UNITED STATES PATENT AND TRADEMARK OFFICE

APPLICATION NO.	FILING DATE	FIRST NAMED INVENTOR	ATTORNEY DOCKET NO.	CONFIRMATION NO.
10/756,379	01/14/2004	Markku Kakko	1381-0308P	2365
2292	7590	02/17/2005	EXAMINER	
BIRCH STEWART KOLASCH & BIRCH PO BOX 747 FALLS CHURCH, VA 22040-0747			SALATA, ANTHONY J	
			ART UNIT	PAPER NUMBER
			2837

Office Action Summary

FIG. 9

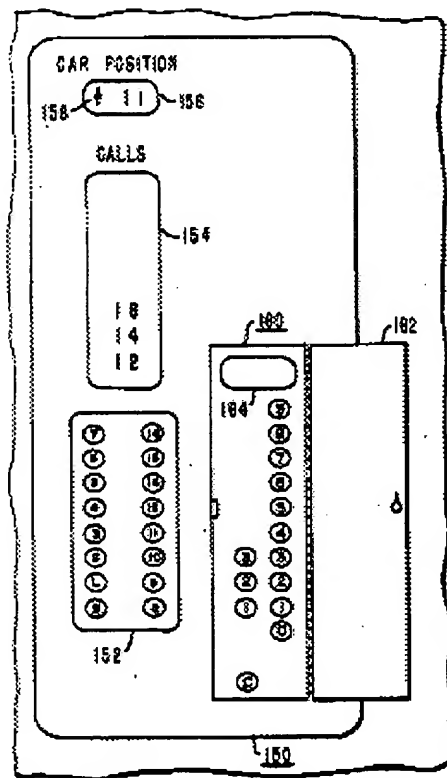
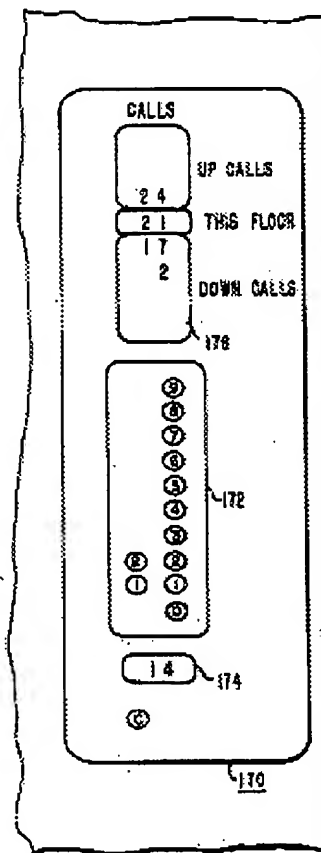
Mandel et al teaches in figures 1-10, an elevator display/operating

Destination floors 154,178 displayed in car and on floor.

Col. 1, lines 51-58 state display in order to be served in car and in order of associated floors in hall.

(interpreted by examiner to be "optimized").

Note arrow 156 for direction indication.
